IFB NO. 31314-FY19-09
LEESBURG TOWN HALL BATHROOM REHABILITATION

ADDENDUM NO. 2

AUGUST 31, 2018

B6 TYPICAL RESTROOM WALL TILE SECTION
SCALE: 6" = 1'-0"

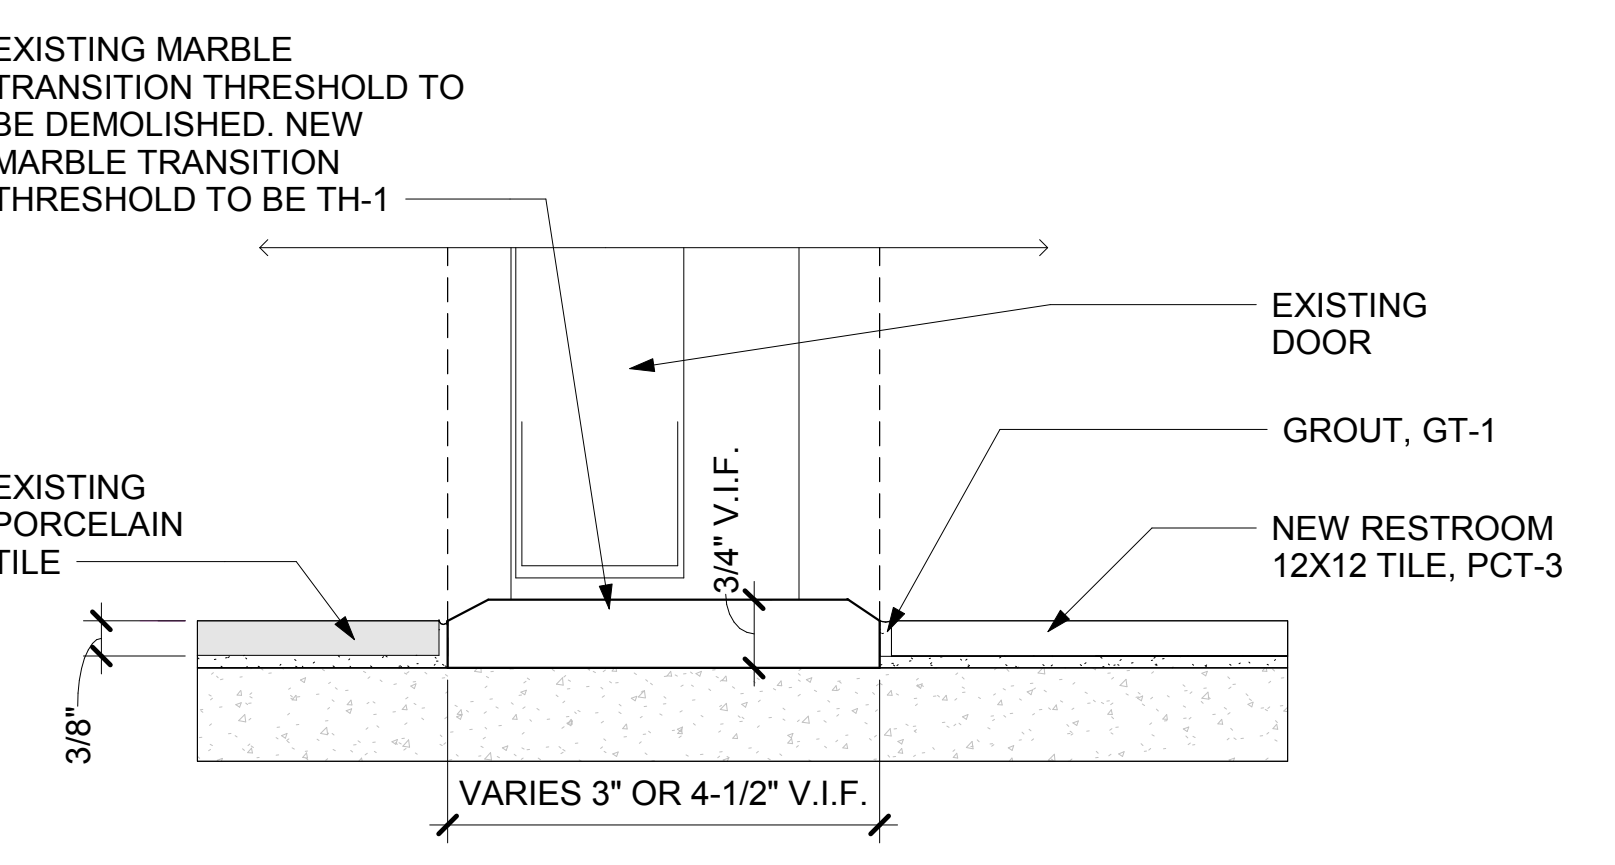
Question 7: Regarding the scope of work for the ceramic tile on the walls: There are two elevations shown for each bathroom on page A-102. Only the women's room has detail B6 – 102 on the wall opposite the toilets.

Is the tile wainscot to be on all walls in the bathrooms? Or Is the detail B-6 – 102 on drawing C2 misplaced and the tile wainscot is to only be on the 'wet walls'? Please clarify.

Answer 7: In accordance with detail B6 and respective plan and elevation views on the revised Addendum 2 drawings (**Attachment 'B'**), all walls within the bathrooms will have tile wainscot to 3ft-3in AFF.
